June 16, 2015

Re: Site Specific Investigation
Mountain West Estates Subdivision
Technical Review

This letter serves to present the findings of our technical review of the site specific investigation prepared by Weston Engineering, Inc. (Weston) and presented to Albany County for the proposed Mountain West Estates Subdivision located within the Casper Aquifer Protection Area. Our review comments will be presented to address the adequacy of this site specific investigation in fulfilling the requirements of the City of Laramie's Unified Development Code, subsection 15.08.040.A.8.

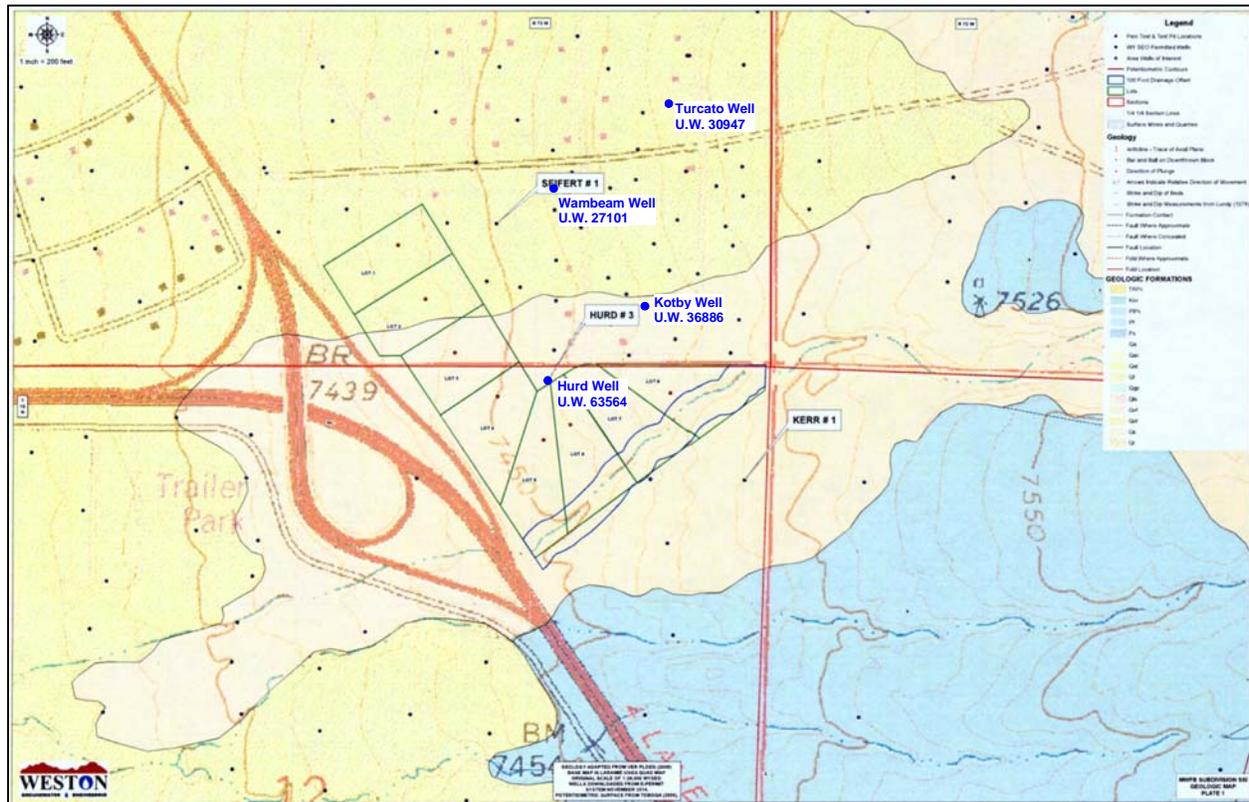
One item that was researched and discussed in later sections of Weston's SSI, but not listed in this section of their report, were the State Engineer's Office completion records for the wells in the proposed subdivision area. A very limited review of the statement of completion records for a few of the wells in the area that are close to the proposed development reveals that "broken limestone" or lost circulation conditions were encountered in some of these wells. The wells with the reported lost circulation and/or "broken" limestone zones are shown in the figure on the following page (blue dots and text) (modified from Weston's SSI Report).

The occurrence of lost circulation during drilling the Casper Formation is typically due to the presence of fractures or voids within the formation. The reference to lost circulation in the nearby wells, especially the Hurd #3 well, is evidence that conduit flow could be present in the area of the proposed development. The lost circulation was documented at depths of greater than 100 feet below the ground surface.
